ADDENDUM

Project Name: WSU Tech Ed Bldg Steam, condensate,
and domestic water piping replacement
Ogden, Utah

Addendum No.: 1

Date: April 15, 2004

D1 STEAM PRESSURE REDUCING STATION DETAIL
SCALE: NONE

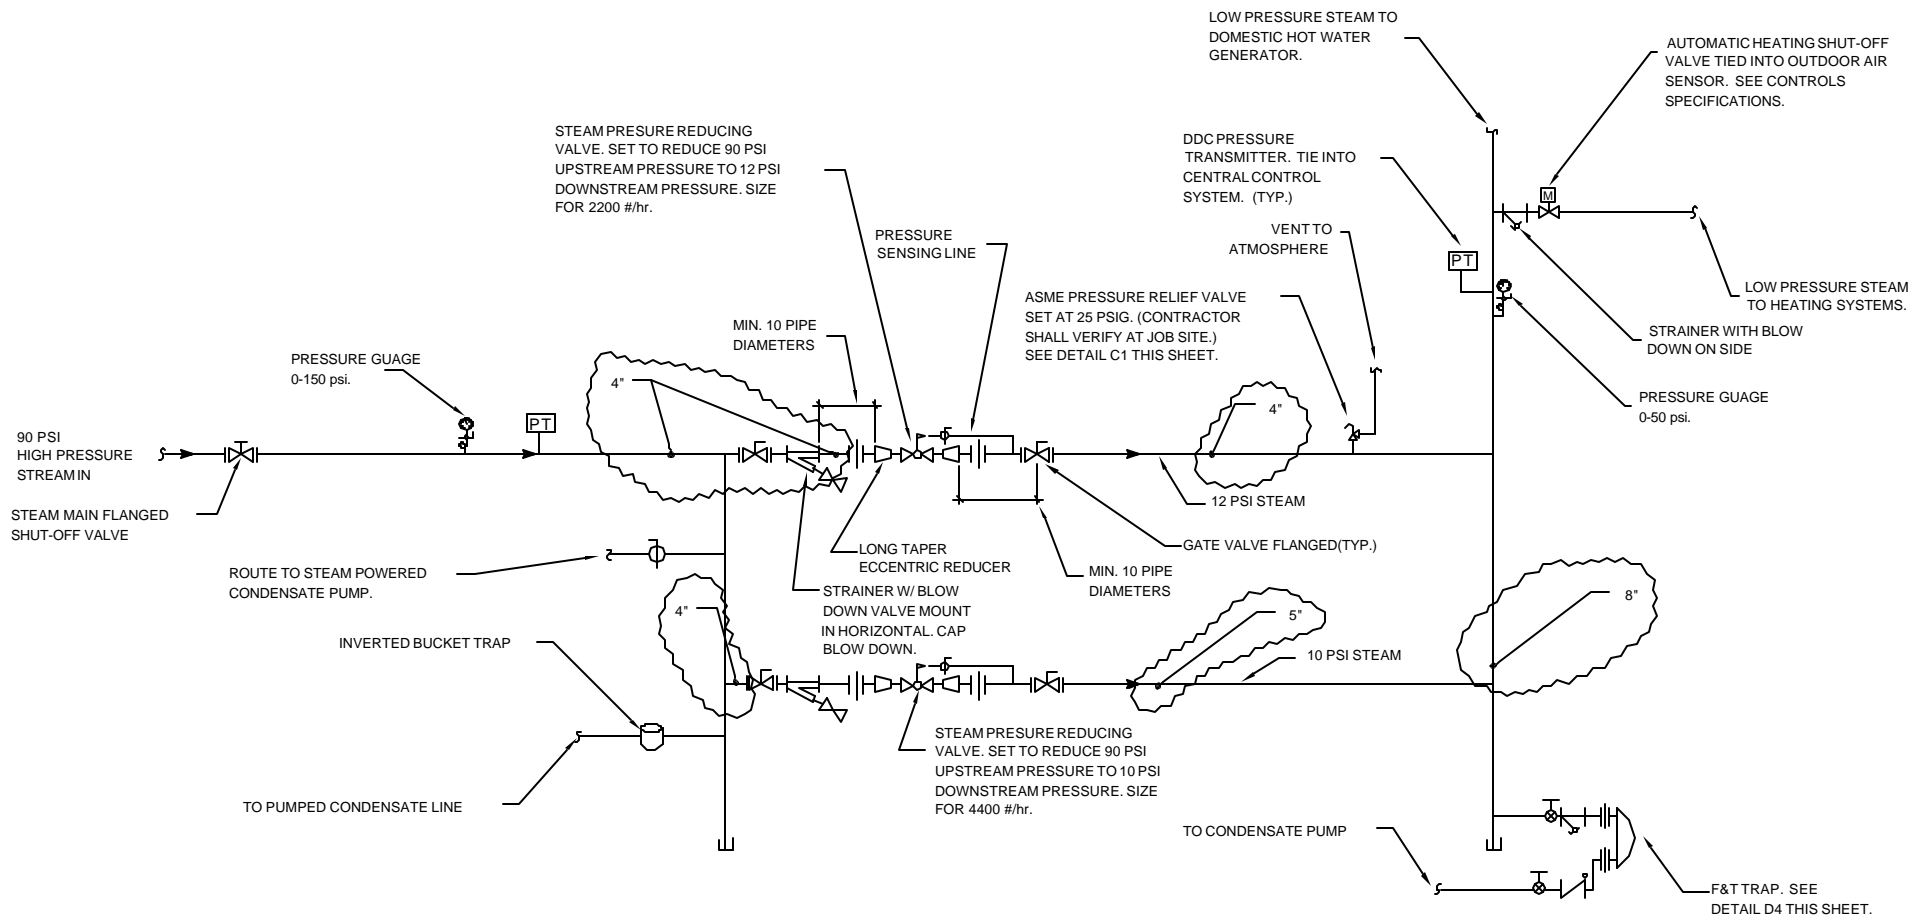
Item VI-3. Sheet ME-501 detail D1: Pipe sizes have been added to PRV station detail for clarification. See attached detail.
